Flight Procedures Cover Page	Task Action: P-NOTAM	Task Type: IAP	Estimated Chart Date: 09/03/2026	APWS Task ID: 06929AE1552B47DDB26172A4B49039A3	APWS Project ID: 948139BAB1FD4123BCF441193490F40B
Procedure: RNAV (GPS) RWY 24 AMDT 1C		Enroute: NO	Specialist: Johnson, Timothy		Agreement Number:
Airport ID: KLKR			Airport City: LANCASTER		State: SC
Facility ID:	Facility Type:	Flight Inspection Remark Type:

RNAV (GPS) RWY 24

LANCASTER COUNTY-MC WHIRTER FLD (LKR)

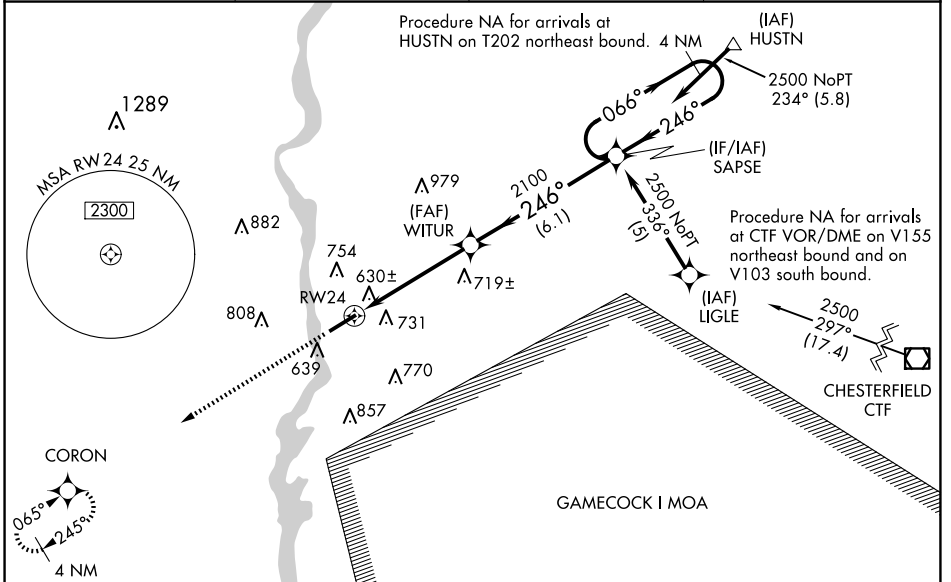
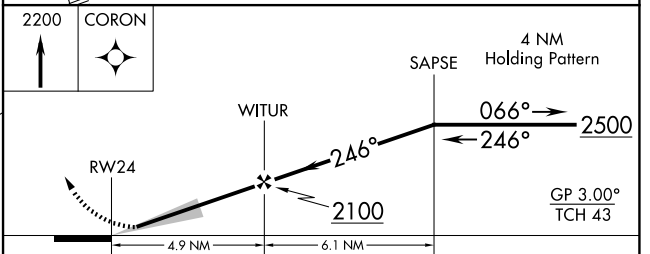
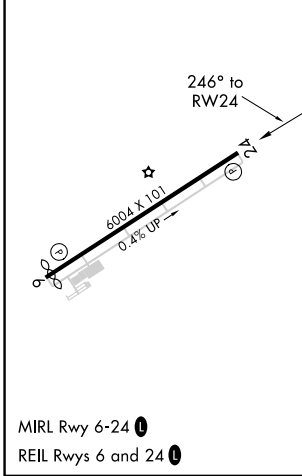
Visibility Initiative (Garmin) - Update IAP visibility minimums IAW Order 8260.3, Chapter 3, Section 3-3. Visibility Minimums.

CATEGORY	A	B	C	D
LPV DA		736-1	250 (300-1)	
LNAV/VNAV DA		1017-2	531 (600-2)	
LNAV MDA	960-1	474 (500-1)	960-1½ 474 (500-1½)	960-1½ 474 (500-1½)
CIRCLING	1040-1 554 (600-1)	1060-1 574 (600-1)	1120-1¾ 634 (700-1¾)	1160-2¼ 674 (700-2¼)
